Fargo VAMC – Refurbish Elevators and Replace Controls

Fargo, North Dakota
Project #19-2481

MARCH 26, 2024

ADDENDUM NO. 2

1 FLOOR PLAN - LIBERTY 1,2,3 - PIT DEMOLITION
1/4" = 1'-0"

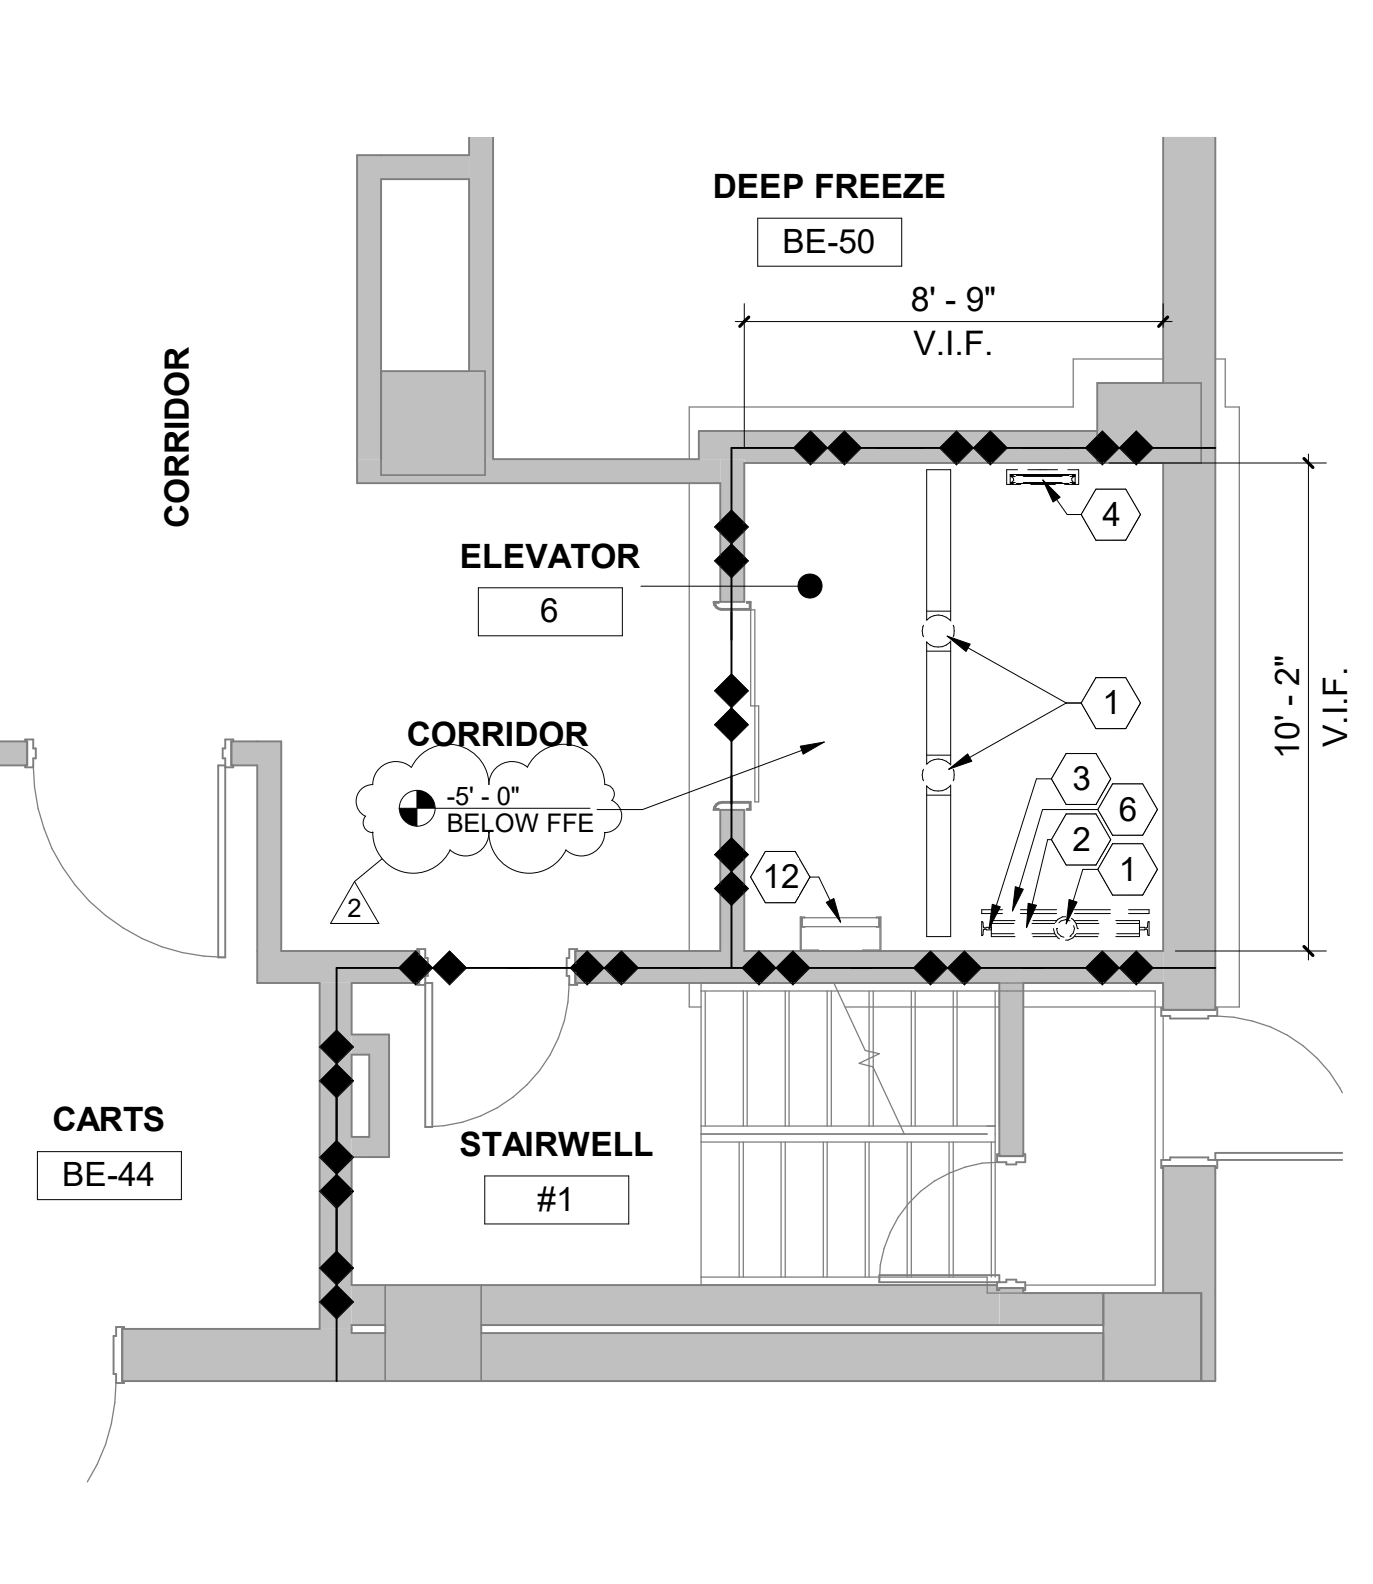
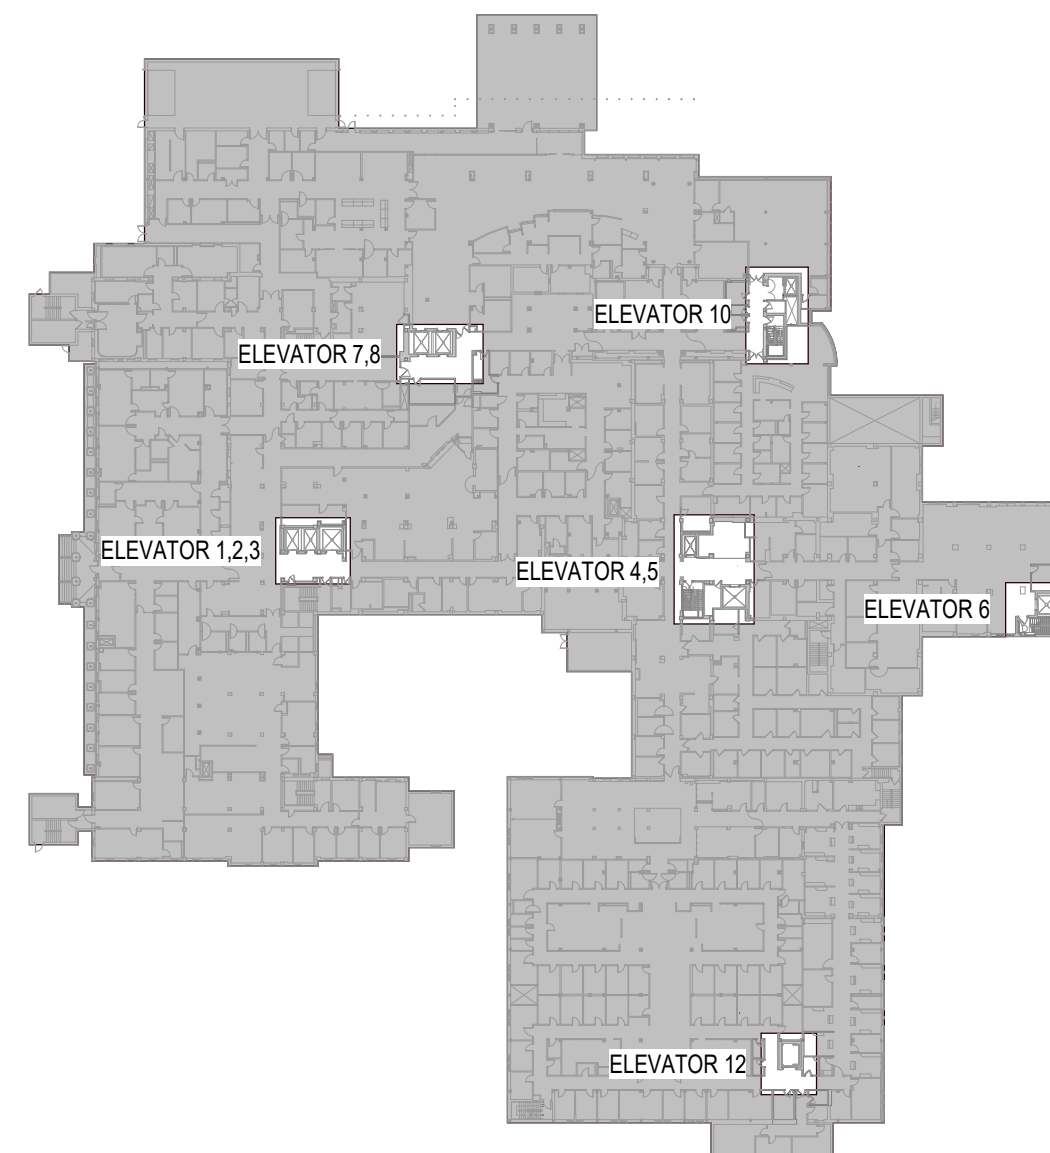
Drawing Sheet AD5.20 ENLARGED PLANS - DEMOLITION – See revised drawing sheet for the adjustment of keynotes # 3, 9, 13 15, 16. Also included is the depth of each elevator pit relative to the floor elevation at the lowest elevator lobby for each hoistway.

- EXISTING METAL PIT LADDER TO REMAIN.
- EXISTING HYDRAULIC PISTONS/JACKS TO REMAIN AND BE REPACKED.
- NOT USED.
- EXISTING LOWER SECTION OF GUIDE RAILS TO BE REMOVED AND REPLACED (APPROX 20LF AT EACH RAIL). INSTALL TO COORDINATE WITH OTHER NEW EQUIPMENT. PROVIDE NEW MOUNTING BRACKETS. APPLIES TO ELEVATOR 7 AND 8 ONLY DUE TO WATER DAMAGE.

- EXISTING LOWER SECTION OF COUNTERWEIGHT RAILS (APPROX 20 LF AT EACH RAIL) AND PIT GUARD TO BE REMOVED AND REPLACED. INSTALL TO COORDINATE WITH OTHER NEW EQUIPMENT. PROVIDE NEW MOUNTING BRACKETS. APPLIES TO ELEVATOR 7 AND 8 ONLY DUE TO WATER DAMAGE.

Drawing Number
AD5.21

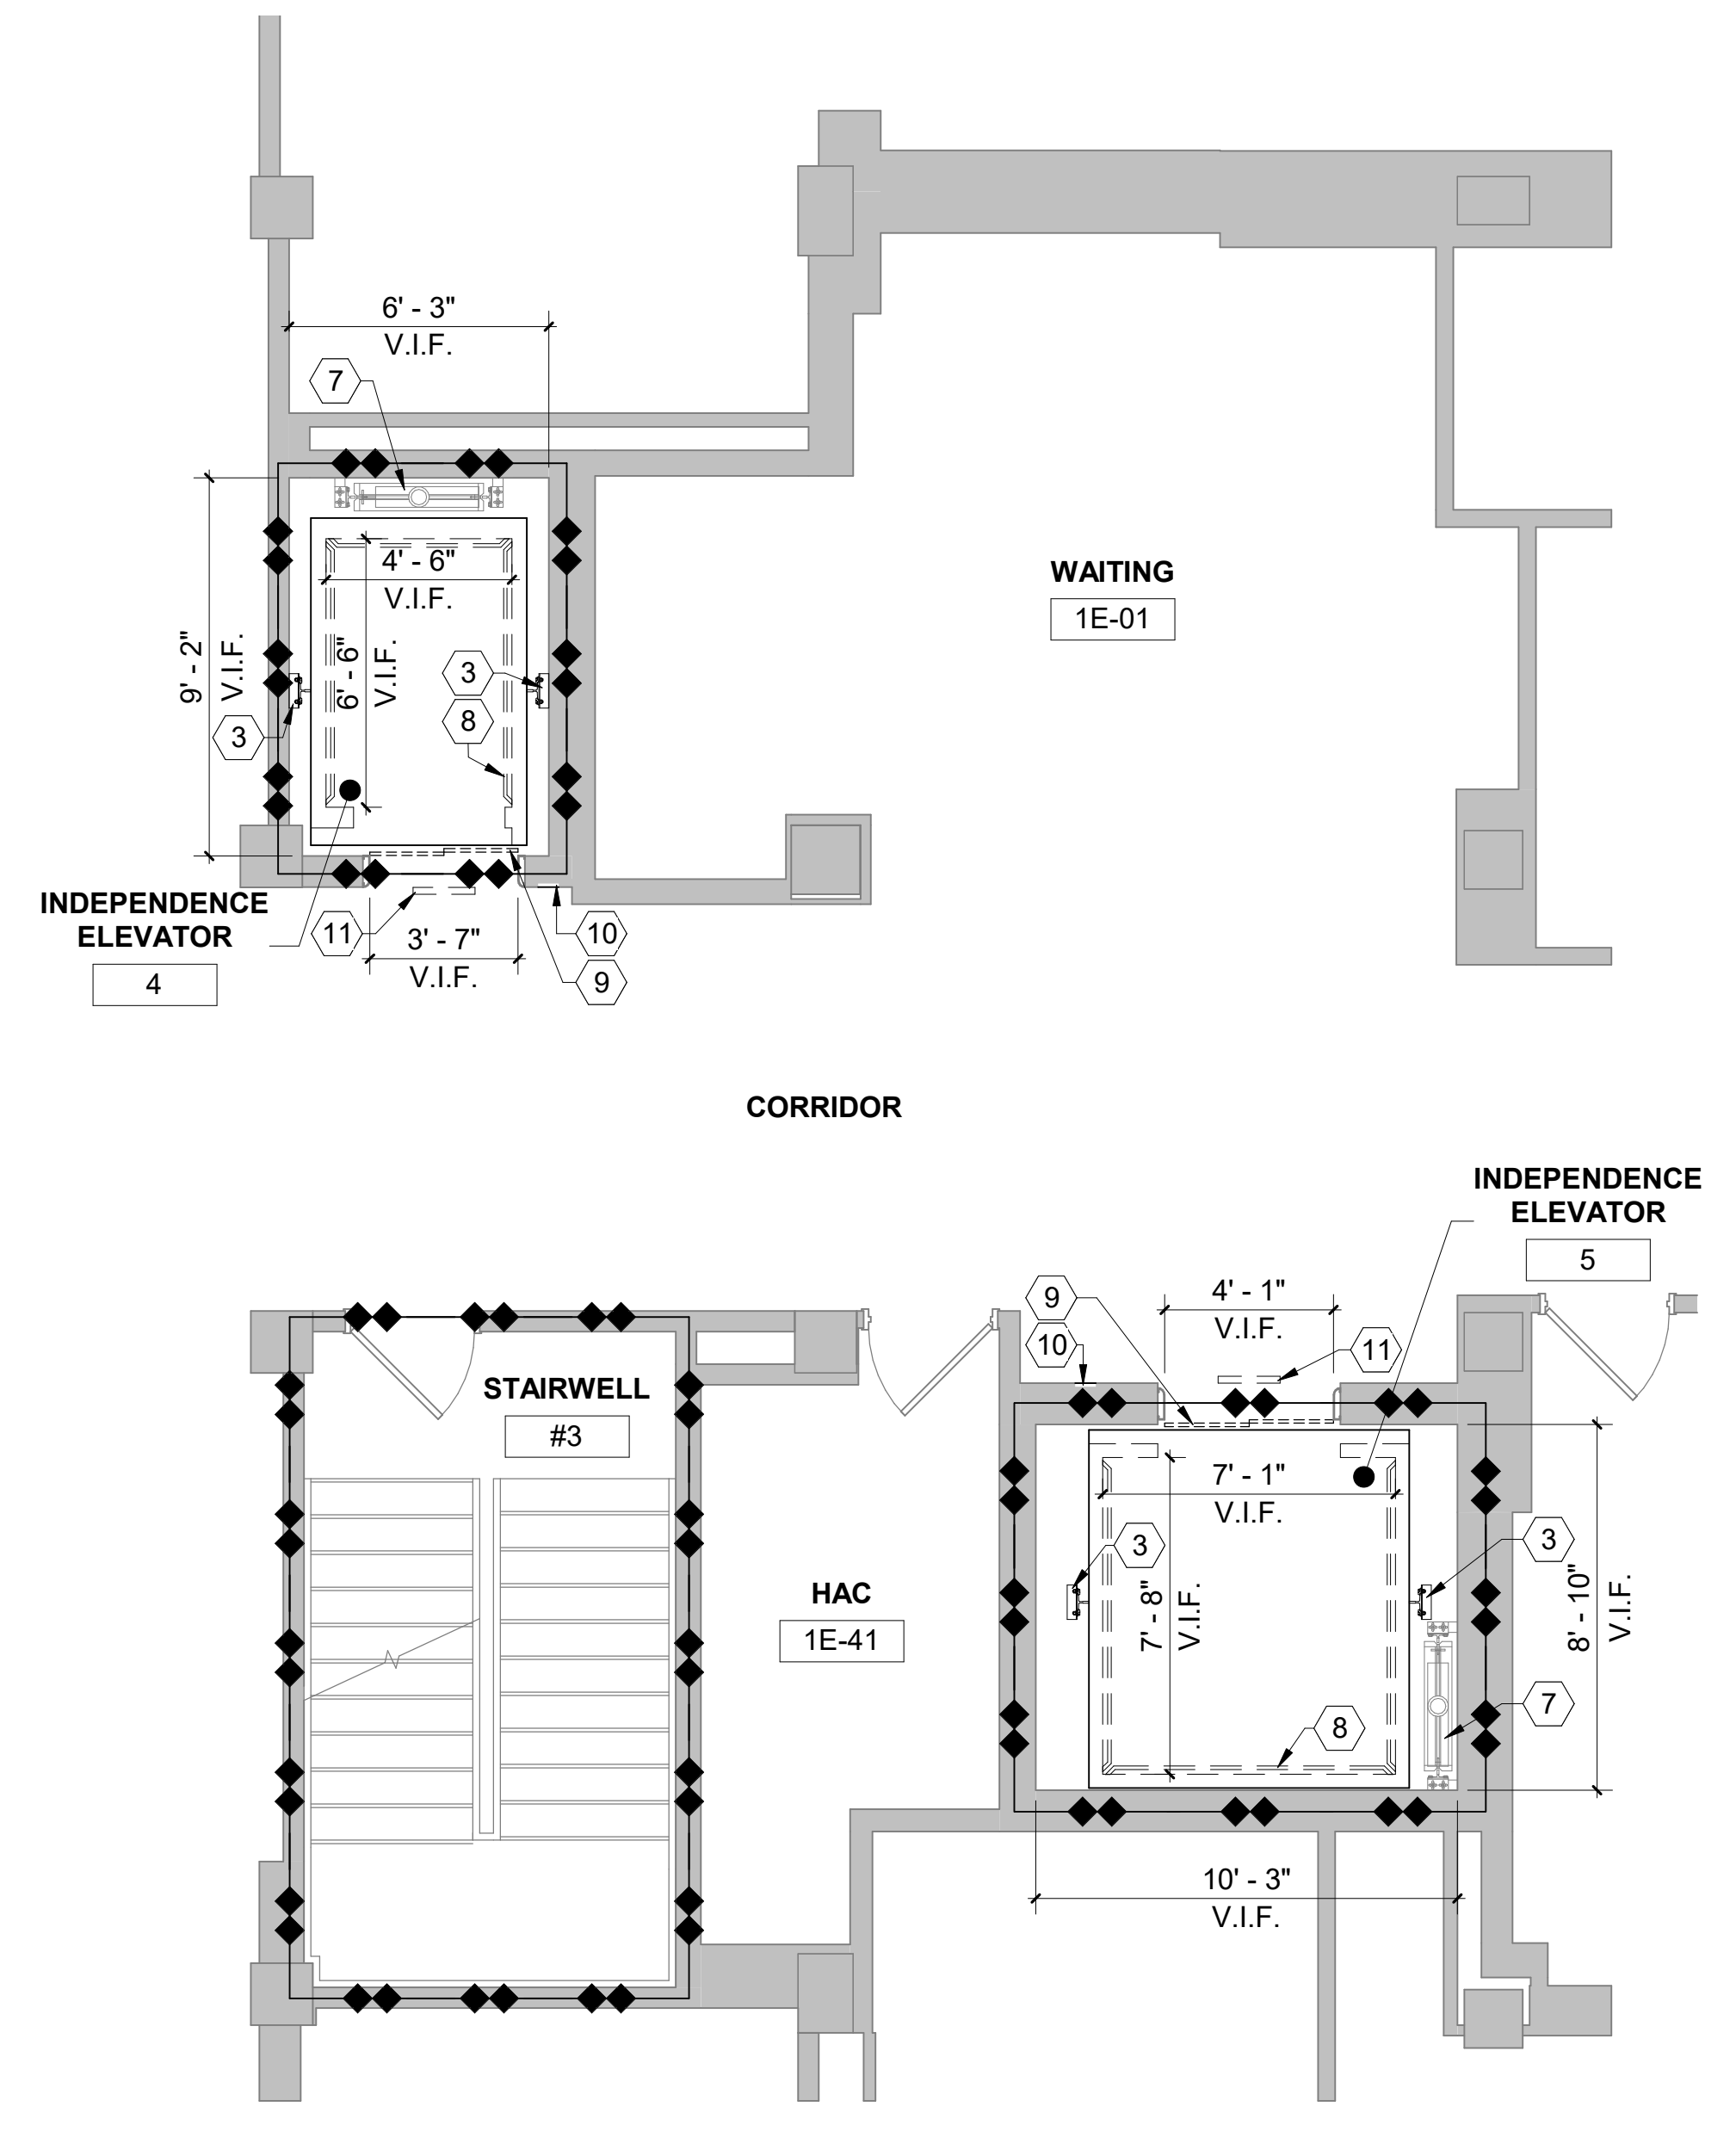
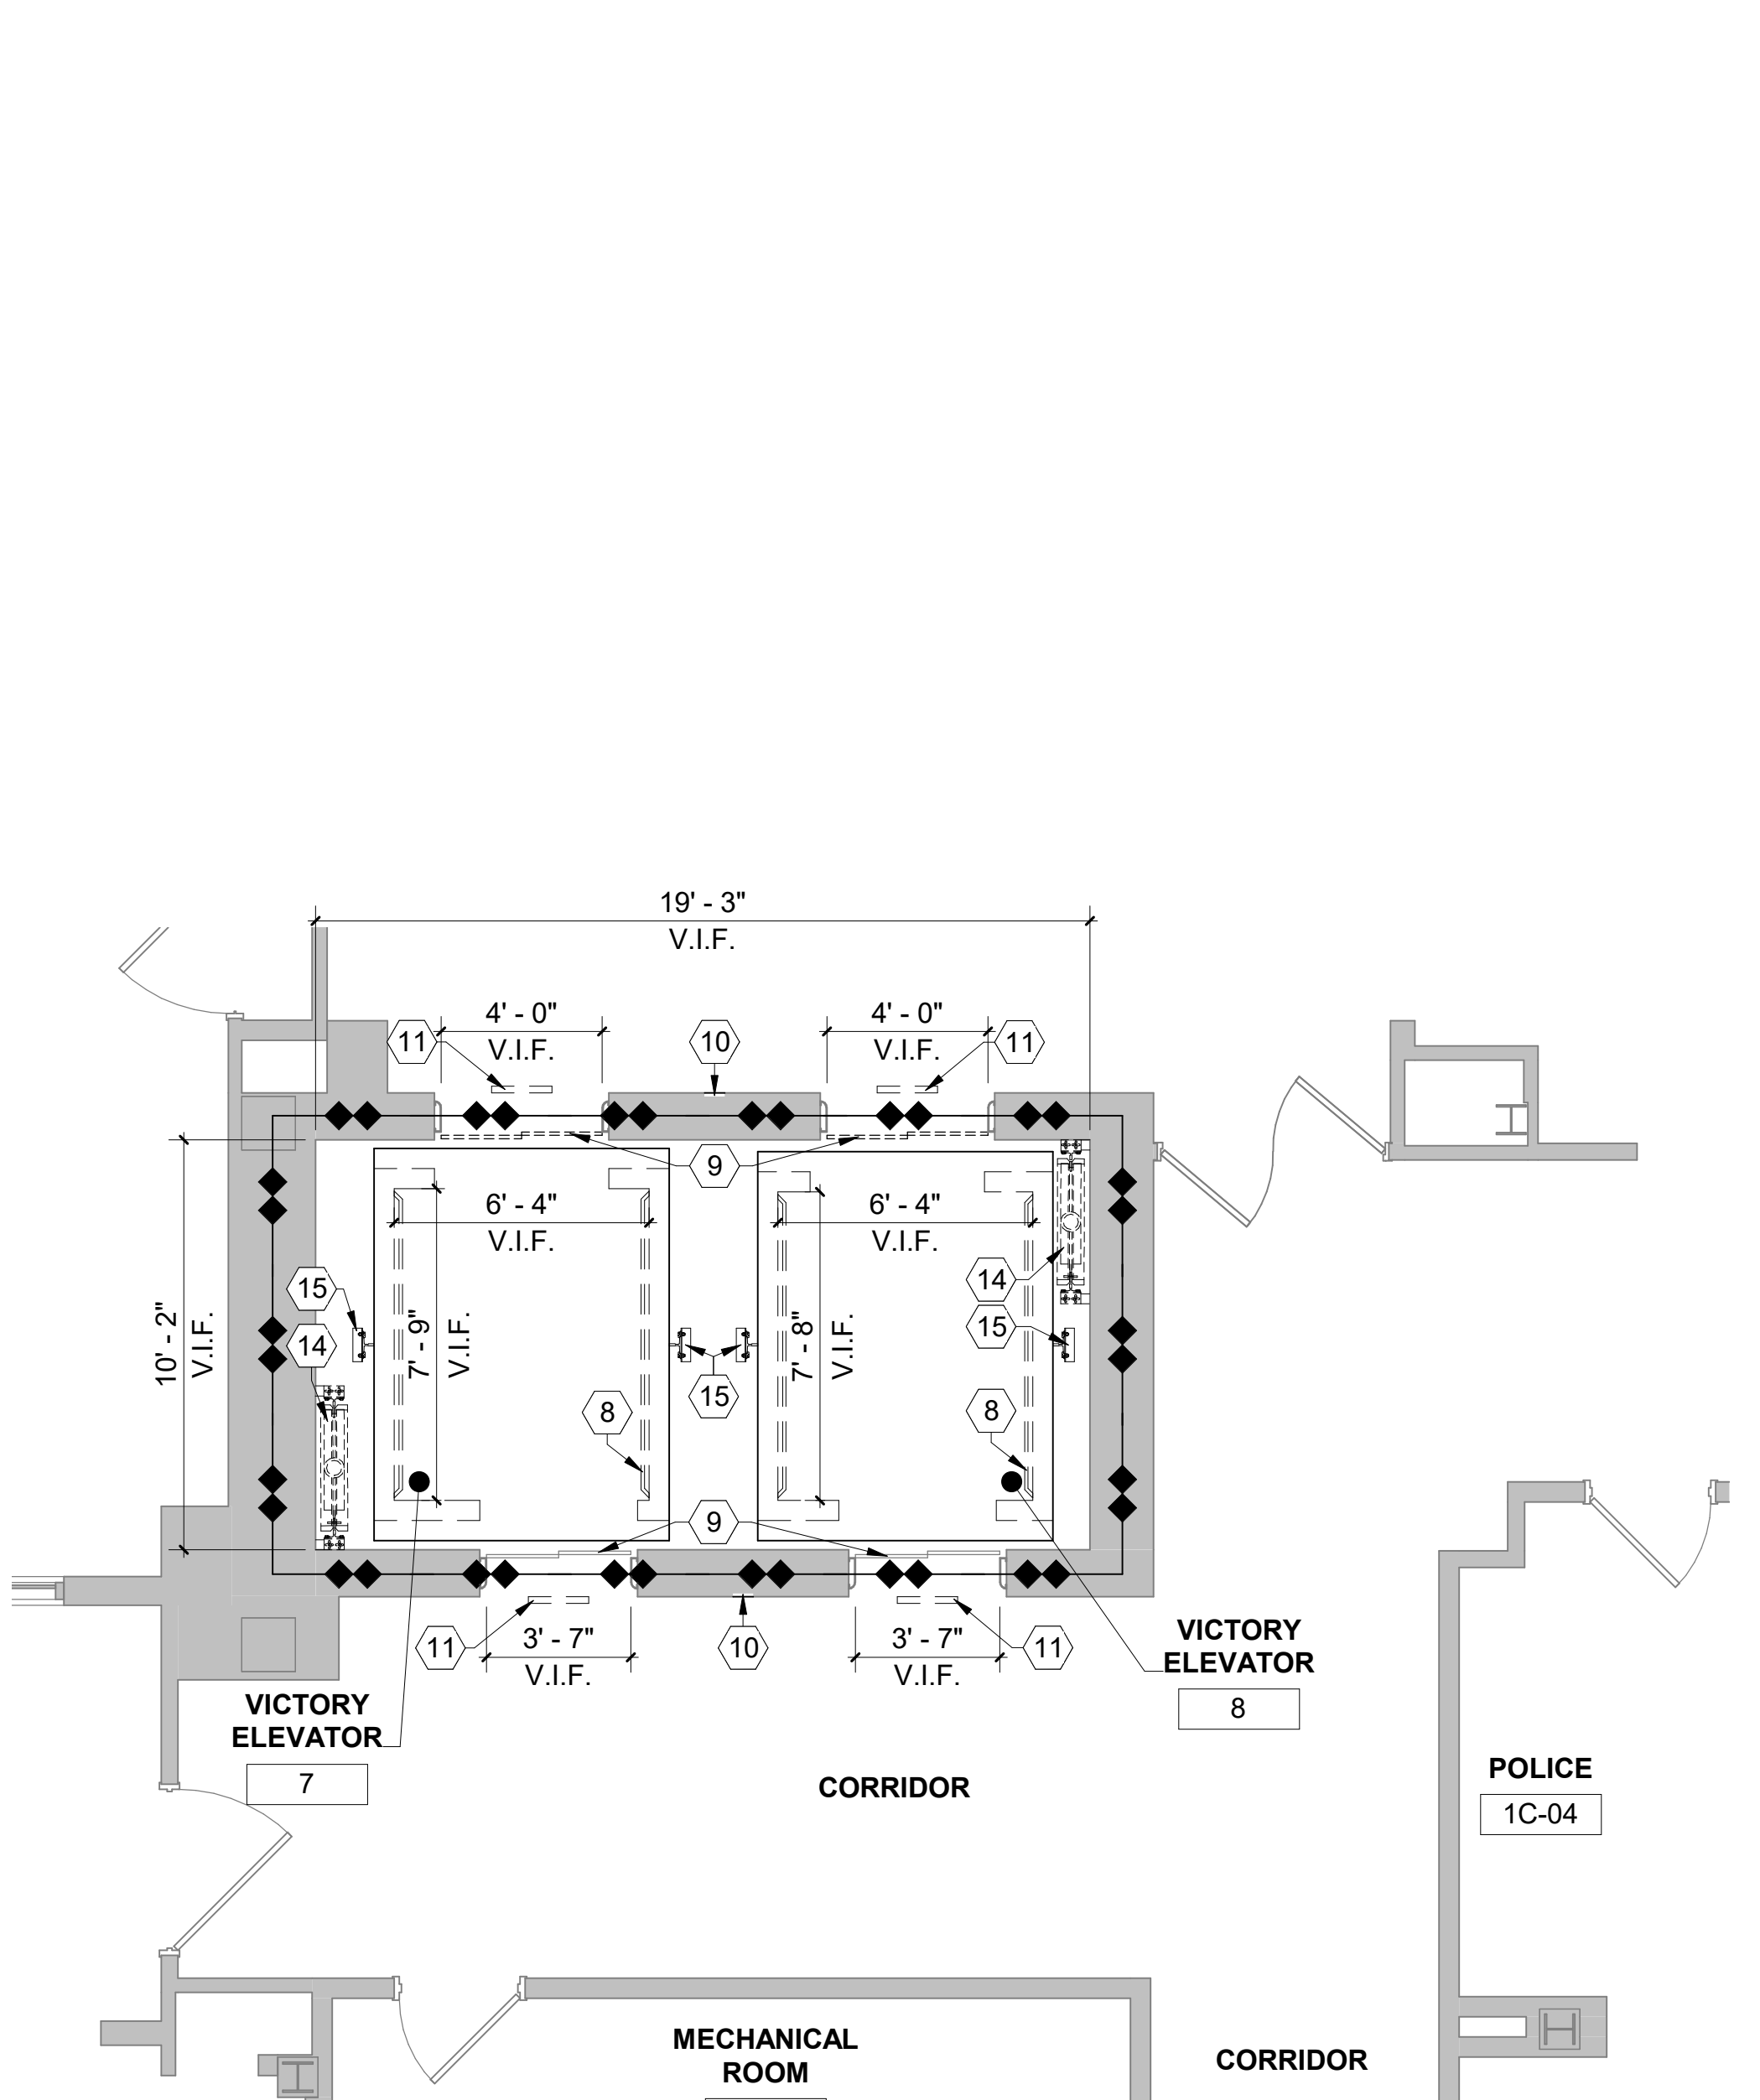
Drawing Sheet AD5.21 ENLARGED PLANS - DEMOLITION – See revised drawing sheet for the adjustment of keynotes # 3, 9, 14, 15.

13. NOT USED.
14. REPLACE EXISTING LOWER SECTION OF COUNTERWEIGHT ASSEMBLY GUIDERAILS IN ELEVATOR 7 AND 8 (APPROX 20 LF AT EACH RAIL). BALANCE COUNTERWEIGHT AS REQUIRED.

15. REPLACE LOWER SECTION OF EXISTING GUIDE RAILS (APPROX 20LF AT EACH RAIL) DUE TO WATER DAMAGE. APPLIES TO ELEVATOR 7 AND 8 ONLY.
